**TECHNICAL MEMORANDUM**

Re: **RI Phase 2 Modification No. 13  
Nevada Environmental Response Trust Site  
Henderson, Nevada  
Ramboll Project No. 1690006943-020**

**Phase 2 RI Investigation - Modification No. 13**  
 Nevada Environmental Response Trust Site  
 Henderson, Nevada

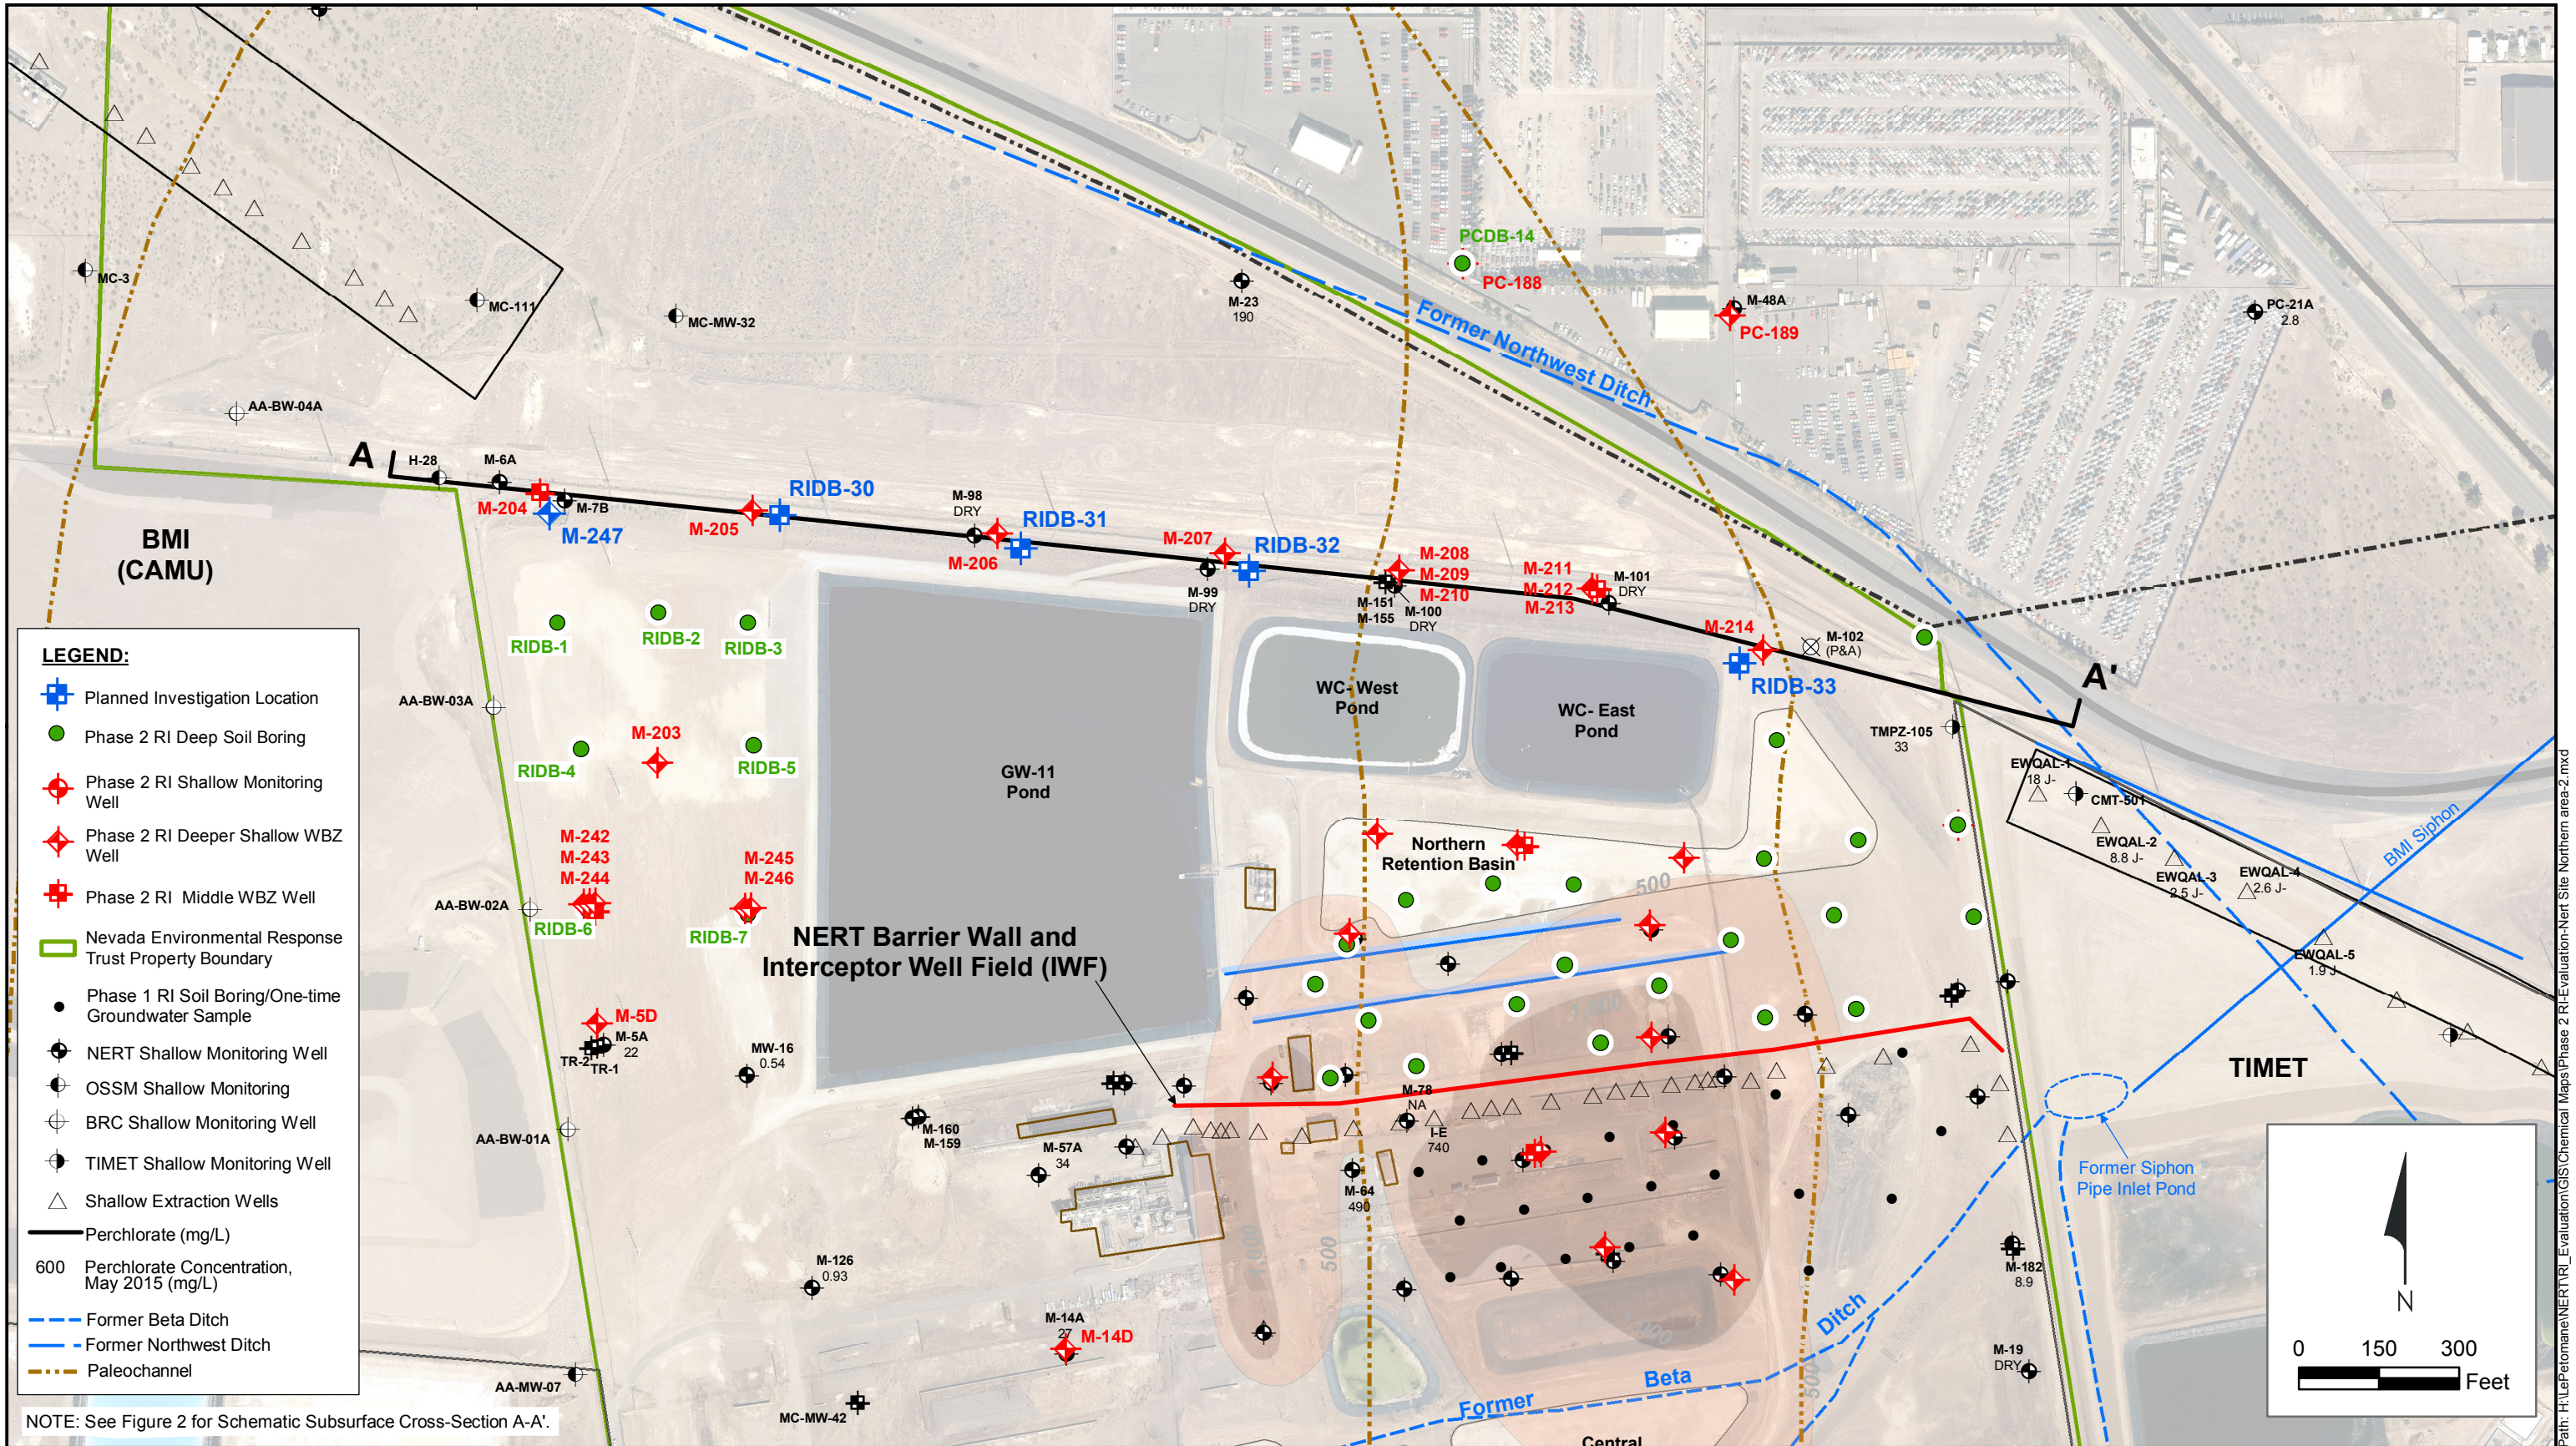
As shown on Figure 1, eleven new groundwater monitoring wells (M-204 through M-214) were installed along the future NERT Site downgradient property boundary as part of the Phase 2 RI investigation. Subsurface conditions along the Site boundary are illustrated schematically on Figure 2. A review of the initial sampling data from these new wells indicates that the vertical extent of perchlorate impacted groundwater has not been fully delineated in the area between new wells M-204 and M-207, and at new well M-214. The approximate vertical extent of perchlorate concentrations greater than 1 mg/L is indicated by the heavy dashed red line on Figure 2, and the estimated vertical extent of perchlorate greater than 0.015 mg/L is indicated by the thin red dashed line. Also of interest is the lateral extent of a permeable zone located within UMCf at a depth of approximately 60-70 feet bgs. This zone was first identified during the installation of the Phase 2 RI soil borings near the Barrier Wall and Interceptor Well Field (IWF). The Vacuum Enhanced Recovery (VER) Treatability Study also investigated this zone with the completion of traditional aquifer testing as well as VER testing. The elevation of this zone near the IWF is between approximately 1,675-1,685 feet mean sea level (msl) datum. Given the permeability of this unit, additional investigation is warranted to determine its lateral extent and associated groundwater quality. Therefore, we are recommending additional investigation at the

**Investigation Locations RIDB-30, RIDB-31, RIDB-32, and RIDB-33.** Four deep soil borings will be advanced adjacent to recently installed RI Phase 2 wells screened in the UMCf. The proposed borings will be drilled to a planned total depth of 150 feet bgs. Soil samples will be collected at 10 foot intervals from 50 feet to total depth and analyzed for perchlorate, chlorate, total chromium, nitrate/nitrite, VOCs, and moisture content. Selected soil samples will also be tested for physical properties. Two deeper monitoring wells will be installed at each boring location to enhance the Site downgradient monitoring network. The initial target screened intervals for the additional monitoring wells are included in Table 1. However, these planned well screens may be adjusted if permeable zones in the UMCf are encountered in the associated soil borings.

**Schematic Subsurface Cross-Section A-A' Showing Northern NERT Site Boundary  
Monitoring Wells and Planned Additional Investigation Locations**  
Nevada Environmental Response Trust Site; Henderson, Nevada

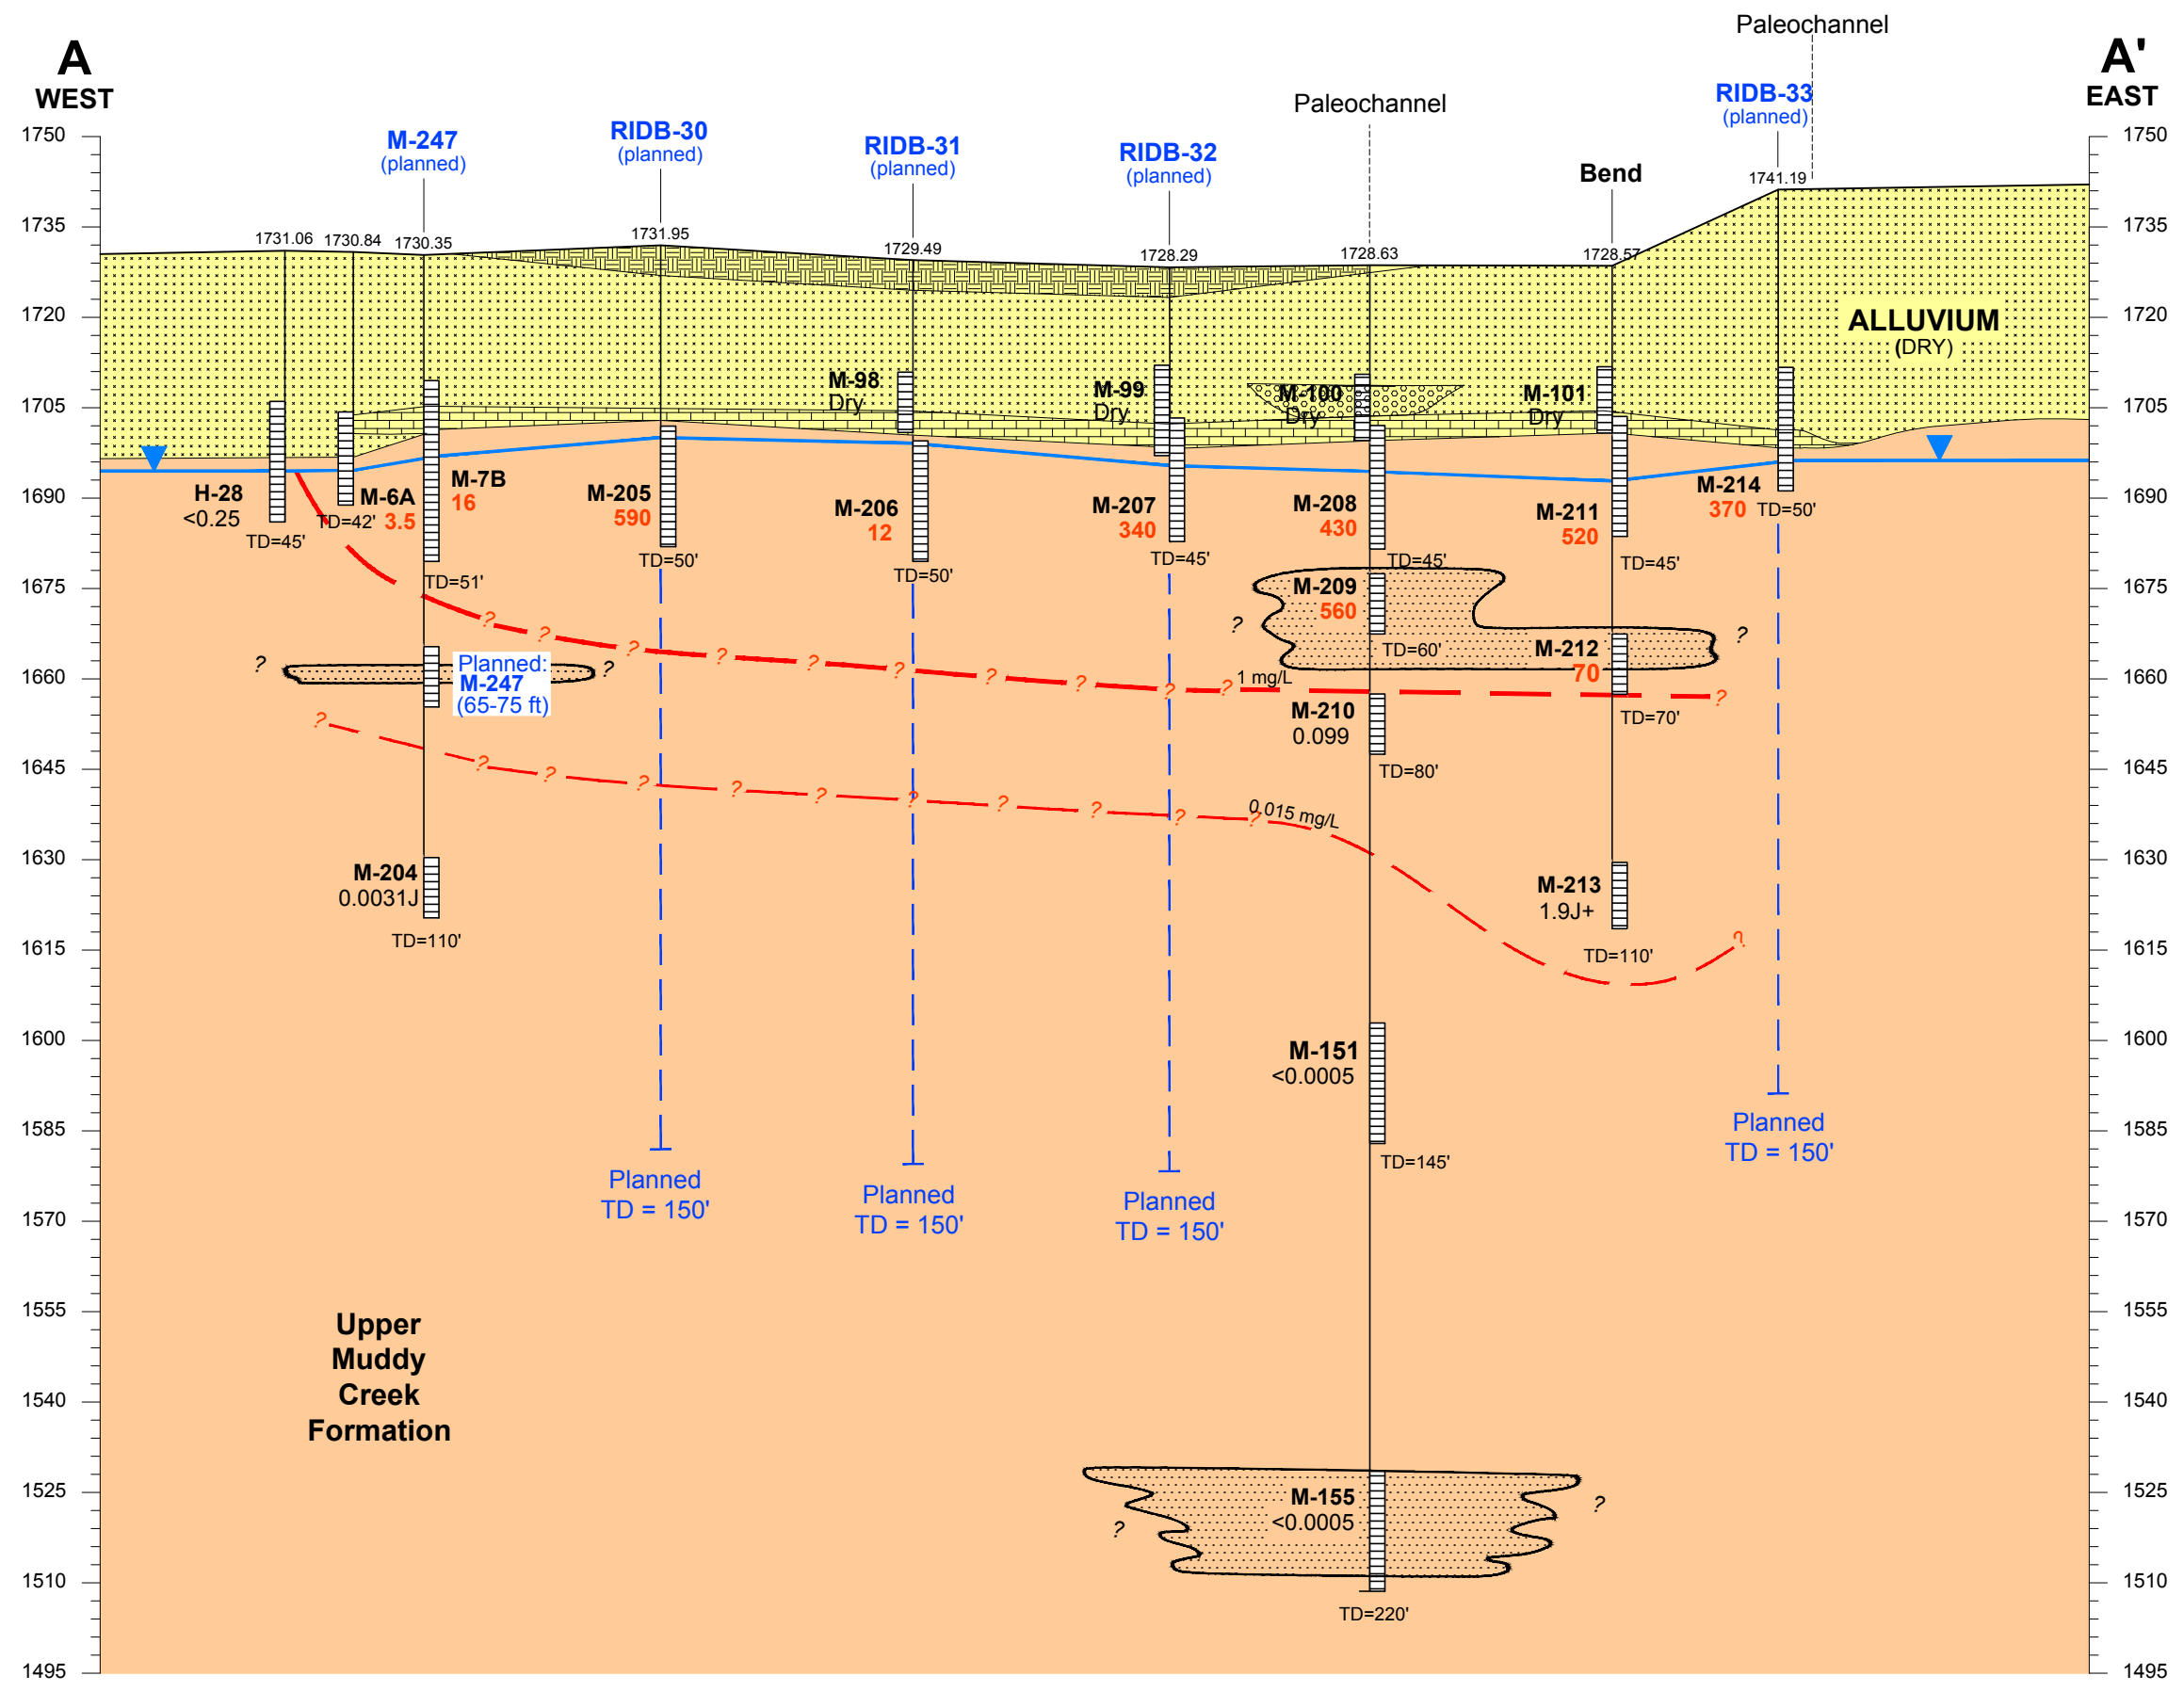
**New well M-247.** One additional well will be installed in the UMCf adjacent to existing well M-7B and new Phase 2 RI well M-204. Planned well M-247 will be screened from approximately 65-75 feet bgs to better define the vertical extent of perchlorate and other COPCs in the interval between the base of existing well M-7B and top of existing well M-204. If it is present, the well screen will straddle the permeable zone observed near the IWF. Table 1 displays the target screened interval and well construction information. The M-247 planned well screen is illustrated on Figure 2.
